Appendix 5

Technical Experts - Review of Submissions to PC53

And Proposed Plan Change 53:
Springvale Structure Plan

STATEMENT OF TRANSPORTATION EVIDENCE BY

Figure 2: Existing Fitzherbert Avenue Extension Road Designation and Proposed Alignment

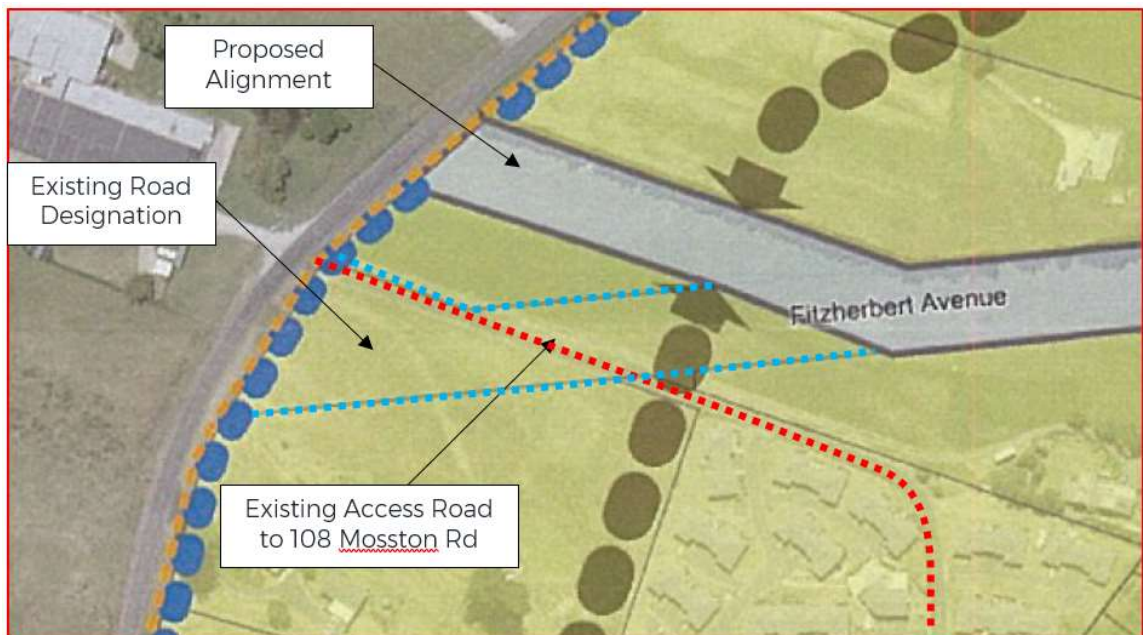
- 3.1 Submission 5 requests consideration is given to retaining the proposed indicative alignment of the Fitzherbert Avenue extension and its intersection with Mosston Road (see Figure 2). The submission also seeks the entrance to the Broadview Lifecare and Village at 108 Mosston Road to be relocated onto Fitzherbert Avenue rather than Mosston Road.

- 3.2 The current roading designation for the Fitzherbert Avenue Extension and associated intersection with Mosston Road as shown within the District Plan connects to Mosston Road within the vicinity of the existing vehicle access to 108 Mosston Road. As shown within Figure 3, the proposed location of the intersection with Mosston Road outlined within the current designation has constrained visibility to the south resulting from curvature in the existing road alignment and hilly topography.

- 3.3 As shown indicatively within the Plan Change 53 Structure Plan, Council now propose to provide a new road designation for the Fitzherbert Avenue Extension to intersect with Mosston Road approximately 100m north of the current designated alignment. This arrangement would provide a safer intersection environment through enhanced sight lines and improved approach angles compared with the current designation.

- 3.7 The proposed alignment of the Fitzherbert Avenue Extension and intersection with Mosston Road provides enhanced safety benefits compared with the alignment outlined within the existing road designation. The submitters suggestion for the existing access to 108 Mosston Road to be removed aligns with the wider intentions of the Structure Plan.

Figure 4: Existing Lifecare and Village Site, and Proposed PC53 Internal Roading Connections

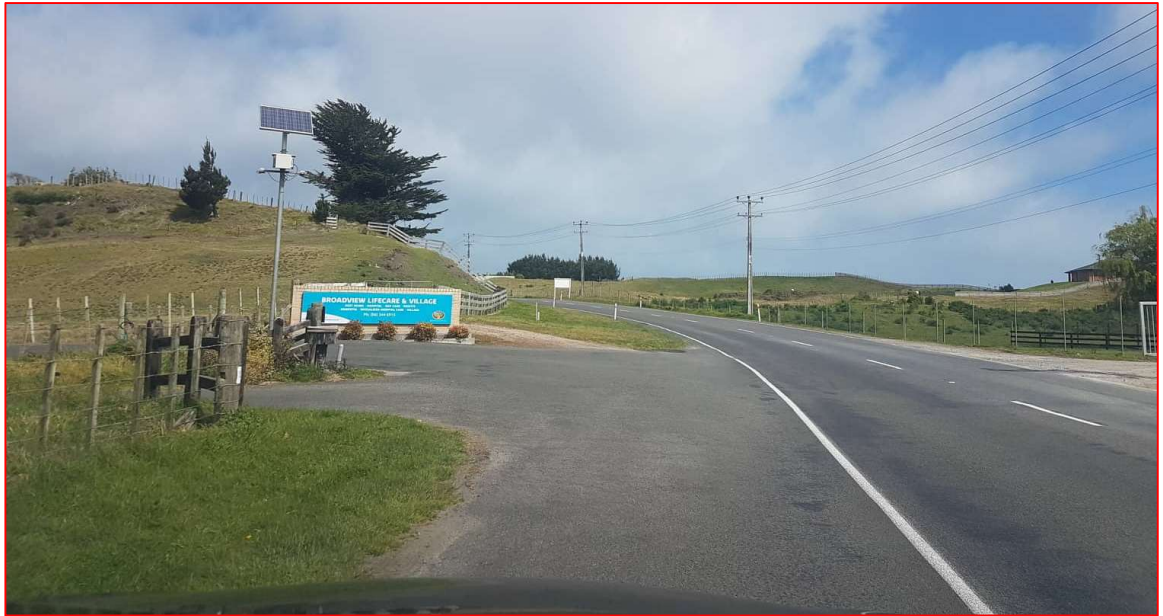
- 3.5 With regards to connections to the Broadview Lifecare and Village site, the Plan Change 53 structure plan provides an indicative arrangement for internal roads within the proposed residential zone, including the area proposed for residential zoning to the south of the Fitzherbert Avenue Extension. As shown within the Structure Plan, a local road connection is proposed along the western side of the Broadview Lifecare and Village site, which would connect to the Fitzherbert Avenue Extension to the north (see Figure 4).

- 3.6 The provision of the internal access road connecting to the Fitzherbert Avenue Extension would, in effect, remove the need for a dedicated access to be provided from the Broadview Lifecare and Village site onto Mosston Road. As such, the submitters request for removing access remains consistent with the wider objectives of applying the proposed Limited Access Road on Mosston Road as outlined within the Plan Change.

Figure 7: Proposed Alterations to Road Designation and Cycleways (Submission 11)

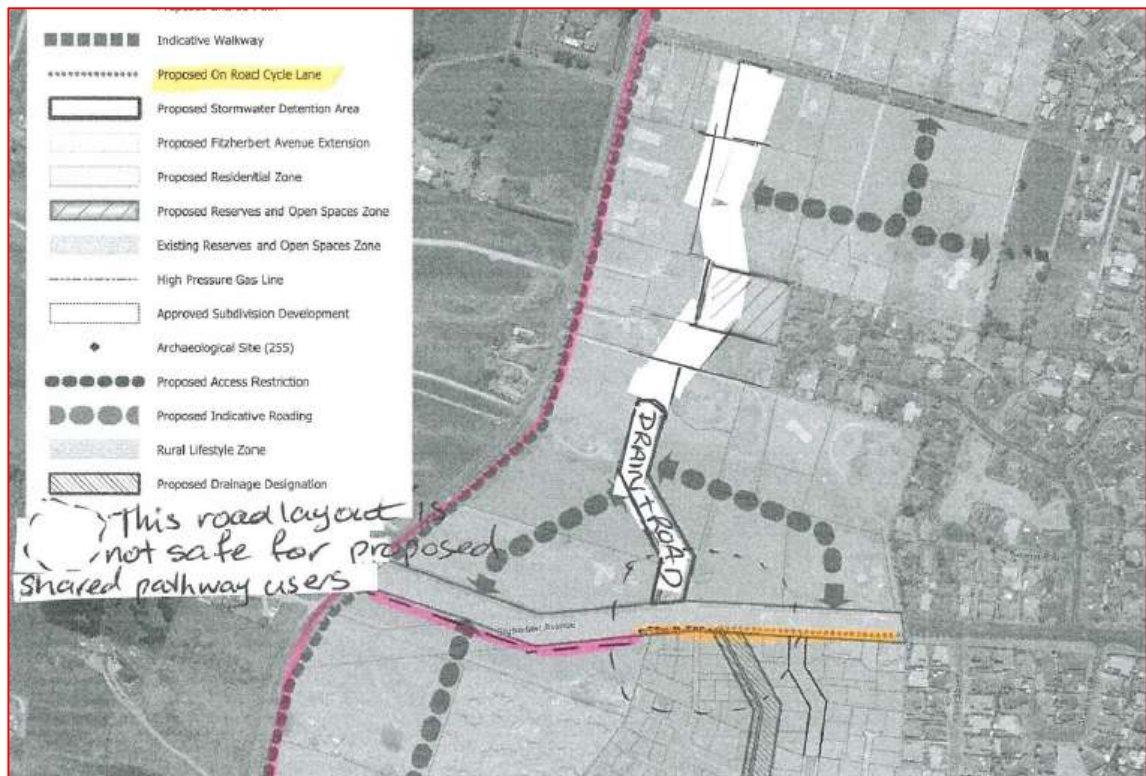
- 6.1 Submission 11 seeks the proposed alignment of the road connection between Fitzherbert Avenue and Fox Road to terminate either side of the land parcel at 130 Mosston Road, and for the proposed shared path to be provided along the eastern side of Mosston Road between Springvale Road and the Titioki Wetland. It also proposes that the on-road cycle lanes on Fitzherbert Avenue continue West to Mosston Road as an off-road shared path (see Figure 7).

- 6.2 It should be noted that severance of the property could be minimised by realigning the proposed route to the eastern extent of the block, although this would have implications on the location of the proposed reserve. Irrespective of this, the road would still encroach on the property, and the response below focuses on the need for providing a north-south connection from a transportation perspective, rather than its alignment.

- 6.13 From a transportation perspective, providing a north-south connection would provide transportation benefits in terms of network permeability and connectivity for active modes, as well as wider traffic benefits relating to resilience, accessibility and route choice.

Figure 8: Proposed Cycle Network (Whanganui Active Transport Strategy, 2017)

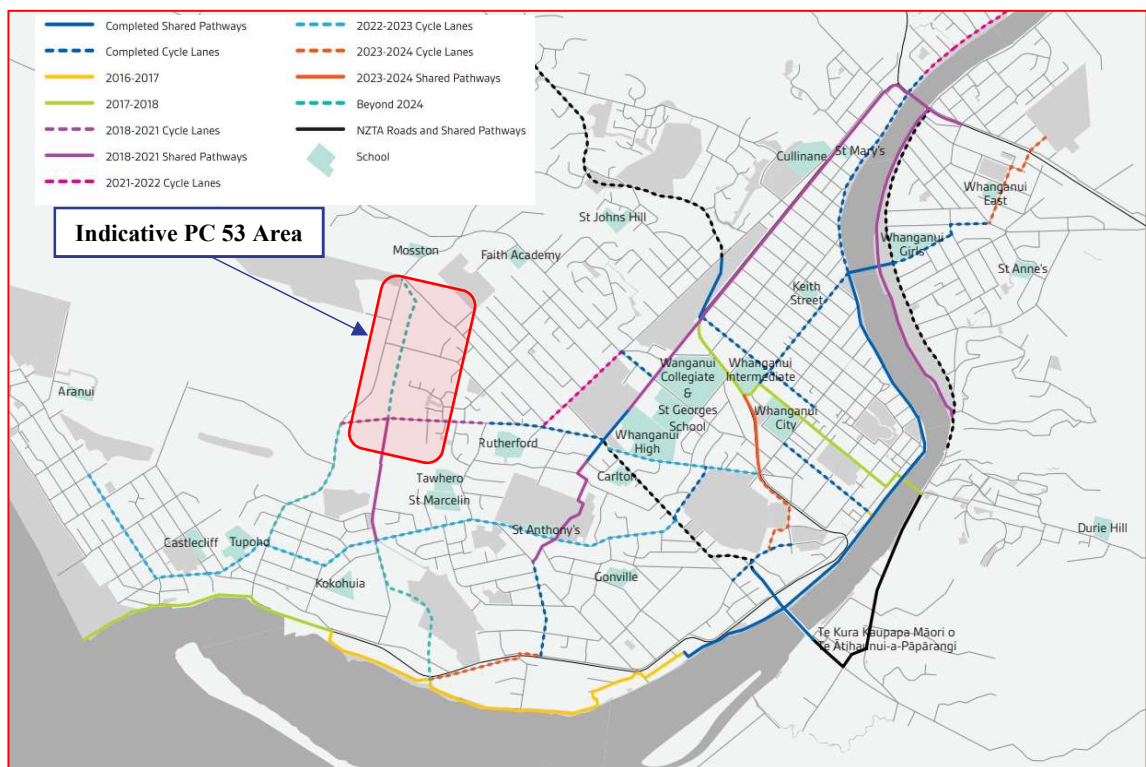
- 6.4 The Whanganui Active Transport Strategy (2017) seeks to achieve a “walk and cycle-friendly district that provides healthy and sustainable travel choices for commuting to everyone”. The Strategy provides an indication of the future cycle routes and indicative timeframes for developing the network (see Figure 8).

- 6.5 The indicative cycle network includes a connection aligning with the proposed north-south road designation through the Plan Change 53 site and an east-west connection along Fitzherbert Avenue (including the extension). The Strategy also indicates a future route on Mosston Road south of the Fitzherbert Avenue intersection.

Plan Change 53 Springvale Stormwater Catchments

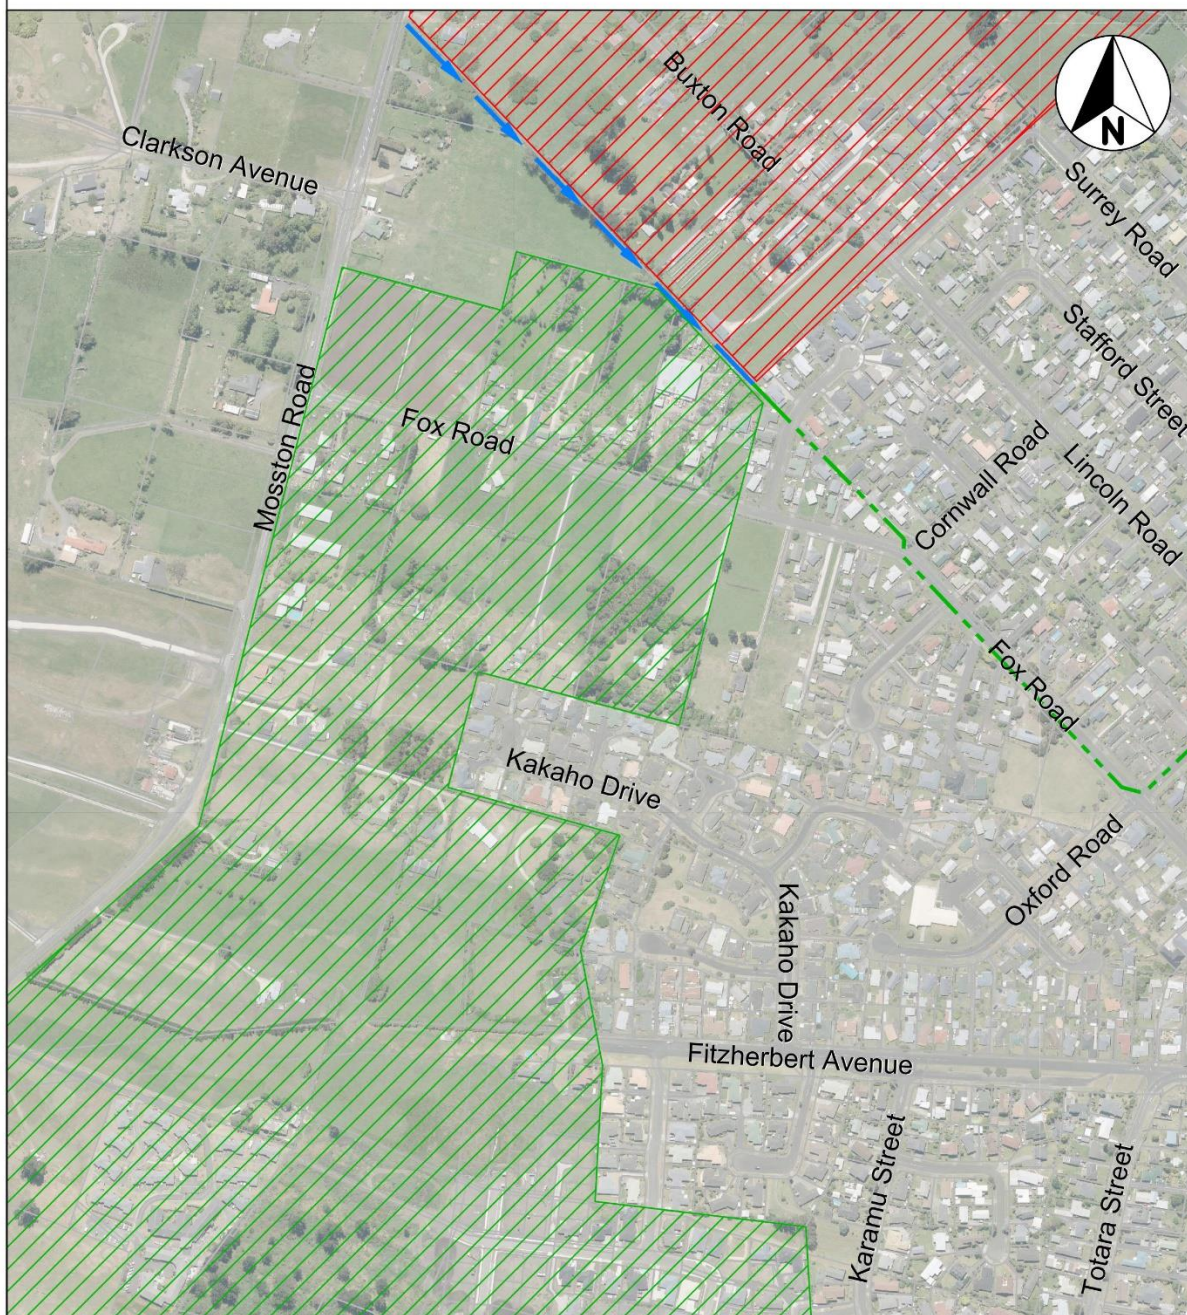
The Buxton Road properties (Those indicated within the Flintoff submission) drain into the Churton Creek/Karamu Stream. While all other areas of proposed plan change 53 are serviced by the Springvale Swale. These are two very separate drainage catchments and require unique management measures. Such measures have not been investigated in detail for the Buxton Road area. This is illustrated on the plan below.

Adding the proposed Flintoff property to the existing system is not possible without downstream upgrades. The Churton Culvert is at capacity and it is not possible to add any additional flows to it without improvement. The implications of adding additional flow would be an increase in the flooding occurrences within the downstream network and potential for additional floors to be inundated.

The original structure plan intended for the Flintoff Development and the wider Buxton Road area to be serviced by the Springvale Swale and NOT the Churton Culvert. The current plan change does not include provisions for this to happen as the swale designation does not extend to the Churton Creek/Karamu Stream. The current plan change does not enable connection to the Springvale swale as the intervening land is in private ownership.

Servicing of the Flintoff proposal would still rely on the Springvale Swale for servicing. (There is no capacity within the Churton Culvert for additional flow or volume).

Infrastructure does not support this proposed change.

Appendix 1 – 111 Mosston Road distances to closest dwellings

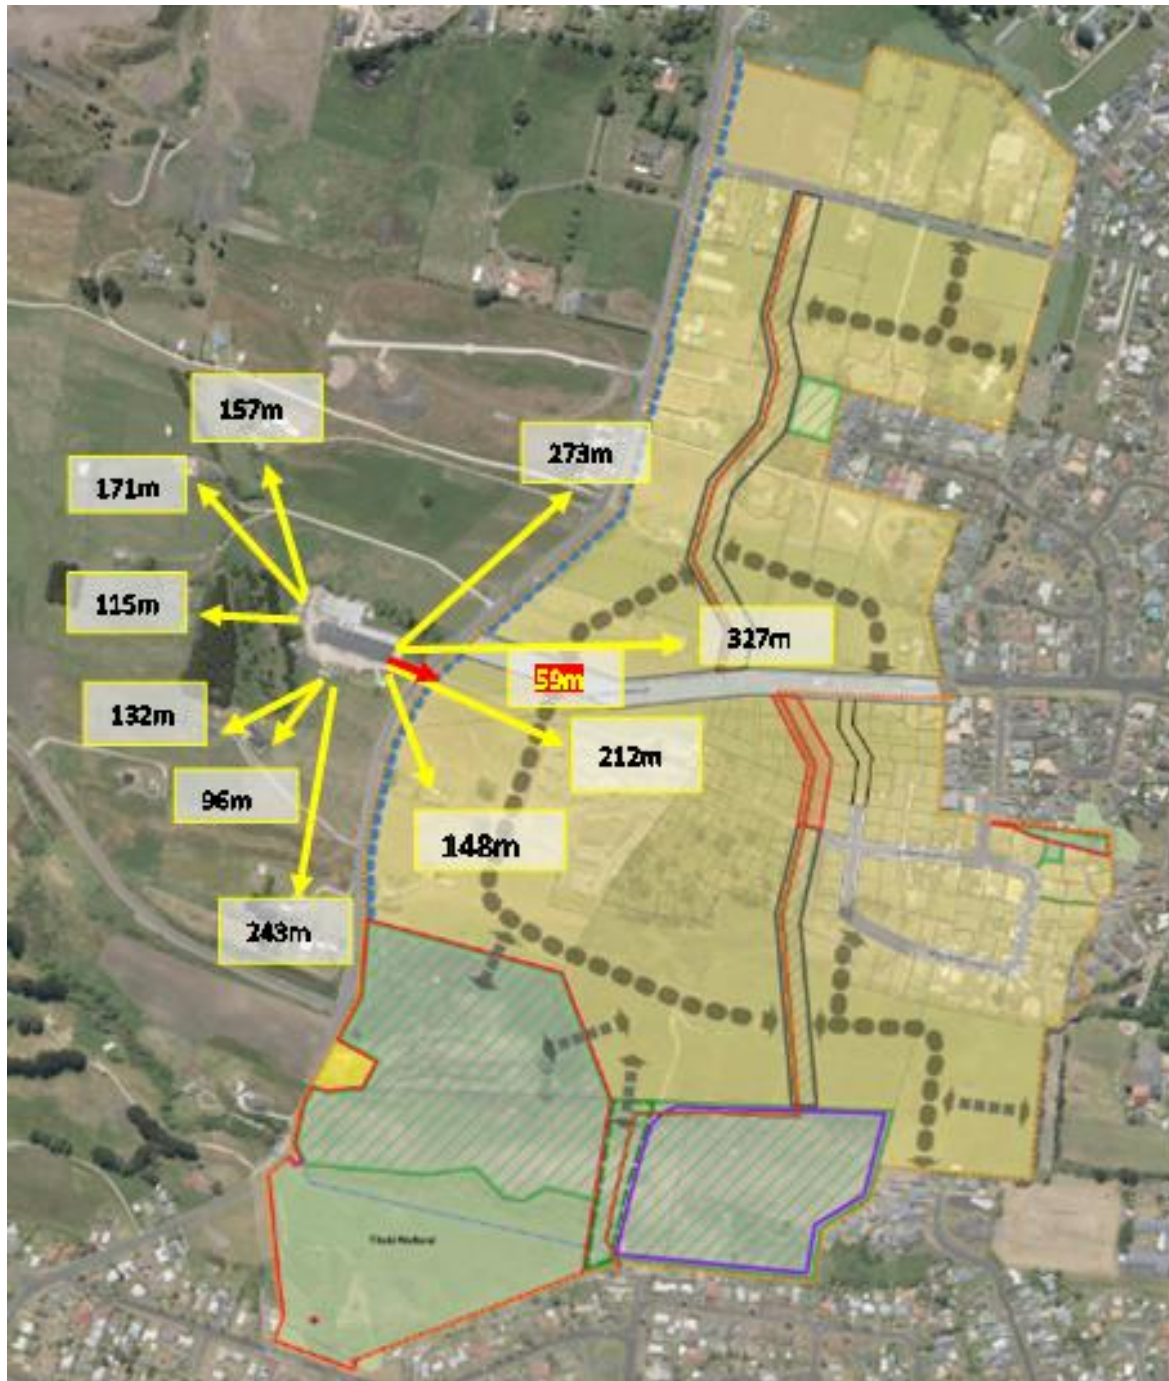
An annotated aerial photograph (provided by WDC) attached to this memo as **APPENDIX 1** shows the approximate distance in metres to each existing dwelling in the area. The red annotations show the closest notional boundary lies at a distance of 59 metres from closest possible activity on site at 111 Mosston Road, should PC 53 be approved. Notional boundaries currently lie as close as 96 metres to activities at 111 Mosston Road, whereas under the proposed plan change this may reduce to 59 metres (in theory at least – the exact distance will depend on the location of the dwellings allowed within the proposed Residential Zone).

- b) As shown on **APPENDIX 1**, the proposed Fitzherbert extension will join Mosston Road directly adjoining the plan change area where the closest dwellings may be located to the activities at 111 Mosston Road.
